RE: Enforcement Hearing

Mineral Mountain Gold, LLC

Mineral Mountain Project, Permit No. M-2014-045

Consideration of a possible violation, cease and desist order, corrective actions, and civil penalty for failure to comply the conditions of an order, permit or regulation.

Photo 5. Two ball mills on upper level of mill.

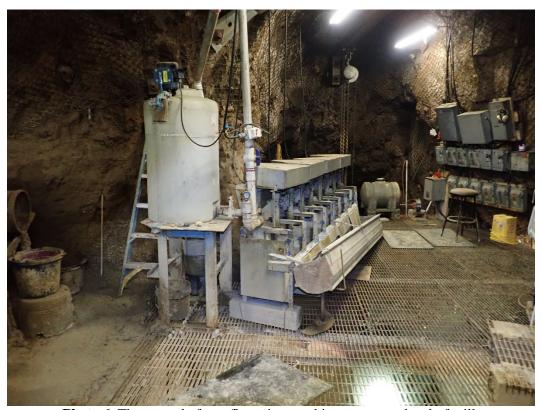
The Division inspected the underground mill facility. The mill facility was off of the main tunnel, approximately 270' in from the portal. The mill consisted of two levels with a separate room used as a sump for the mill tailings. The upper level contained two 1-ton/hour ball mills, two floatation machines (rough and finishing circuits), a mixing tank, a chemical storage room, and a chemical mixing area. The chemical storage area on the upper level of the mill contained two 55 gallon drums of xanthate and two 55 gallon drums of MIBC frother. The Operator stated xanthate is mixed and diluted by hand in 5 gallon buckets then stored in one of three 35-gallon containers where it is pumped into the mill circuit at three locations: before the regrind ball mill, after the regrind ball mill, and before the rough floatation machine. The lower level of the mill contained four 1,250 gallon fresh water tanks, two shaker tables, a regrind ball mill, and a floatation concentrate settling bin.
